# Work Order ID 88715

Item Name: Crosstube Assembly, Mid Fwd

<b>DART AEROSPACE LTD</b> HAWKESBURY, ONTARIO, CANADA	
DRAWING NO. D206-667-147	REV. A SHEET 1 OF 4
TITLE CROSSTUBE ASS'Y (206L MID FWD)	SCALE NTS
COPYRIGHT © 2010 BY DART AEROSPACE LTD THIS DOCUMENT IS PRIVATE AND CONFIDENTIAL. NO REPRODUCTION OR DISSEMINATION OF THIS DOCUMENT IS ALLOWED WITHOUT THE WRITTEN PERMISSION FROM DART AEROSPACE LTD.

DRAWING NO. D206-667-147	TITLE CROSSTUBE ASS'Y (206L MID FWD)	REV. A	<b>DART AEROSPACE LTD ENGINEERING ORDER</b>	D.E.O. NO. D206-667-147-A-1	SHEET NO. SHEET 1 OF 1	SCALE NTS
DRAWN 92	CHECKED AJS	MFG. APPR. PB	APPROVED JMD	DE APPR. H		
DATE 11.07.15	DATE 11.07.20	DATE 11.07.21	DATE 11/07/21	DATE 11.07.21

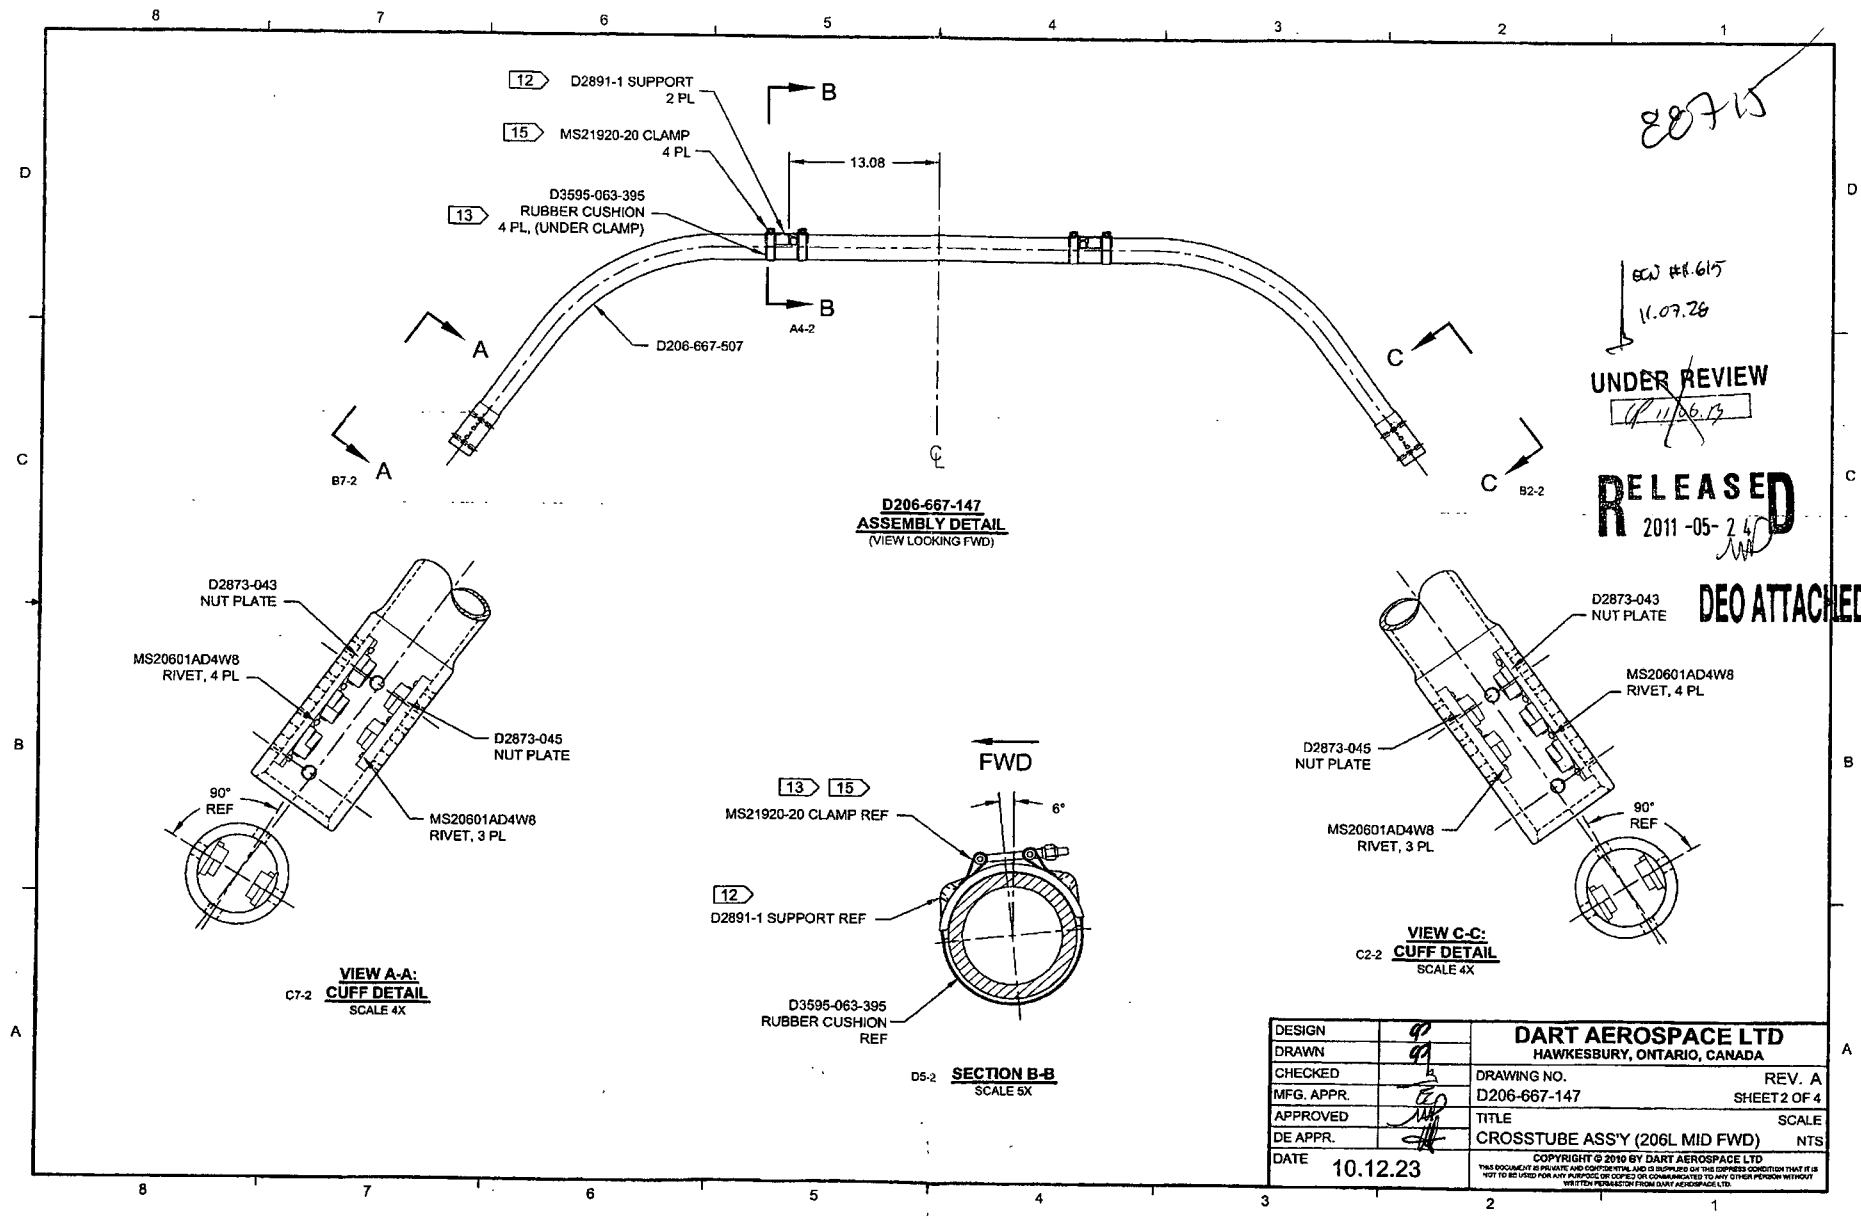
**PURPOSE:**

REPLACE MAGNOBOND WITH PROSEAL.

NOTE 12 & 15, SHEET 1 IS AMENDED AS FOLLOWS:

- 12) TO INSTALL D2891-1 SUPPORT: ABRABE MATING SURFACE OF SUPPORT AND CROSSTUBE WITH 180-GRIT SANDPAPER AND REMOVE RESIDUE WITH MEK (OR EQUIVALENT). APPLY A 0.04" TO 0.07" THICK LAYER OF PROSEAL 890 CLASS B-2 (OR AMS-S-8802 CLASS B-2) SEALANT TO MATING SURFACE OF SUPPORT.
- 15) TORQUE CLAMPS 80 TO 100 IN-LB. ENSURE AT LEAST 1.5 THREADS SHOWING IN SAFETY AND THAT NUT HAS NOT BOTTOMED-OUT AFTER TORQUING. **PRIOR TO PACKAGING, RE-CHECK TORQUE ON CLAMPS AFTER PROSEAL 890 SEALANT HAS CURED FOR 72 HOURS.**

**DETAIL L:  
CROSSTUBE CUFF**  
NOT TO SCALE

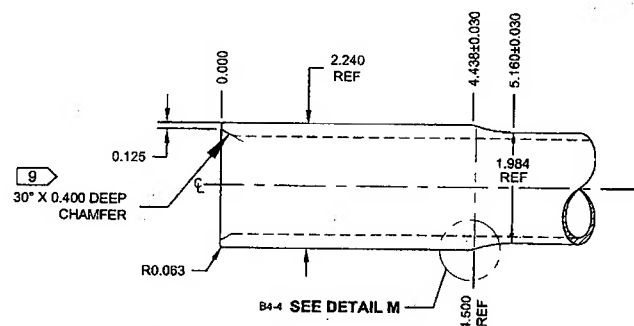
Root Cause	Date	Step	Qty	Description of work order update or Non-conformance	Initial Chief Eng	Action Description	Sign & Date	Verification	QC Inspector
Doc/Data <input type="checkbox"/>	12/8/13	100	1	CUFF IS 0.002" below tolerance on O.D.	 12/8/13	Acceptable	 12/8/13	 12/06/13	 12/06/13 057042
Equip/Tooling <input checked="" type="checkbox"/>									
Operator <input type="checkbox"/>									
Material <input checked="" type="checkbox"/>									
Setup <input type="checkbox"/>									
Other <input type="checkbox"/>									
Process <input type="checkbox"/>									
Supplier <input type="checkbox"/>									
Training <input type="checkbox"/>									
Unapproved <input type="checkbox"/>

CUFF Not in tol.  
(TAPER/QUALITY)  
2.242" - 2.238"
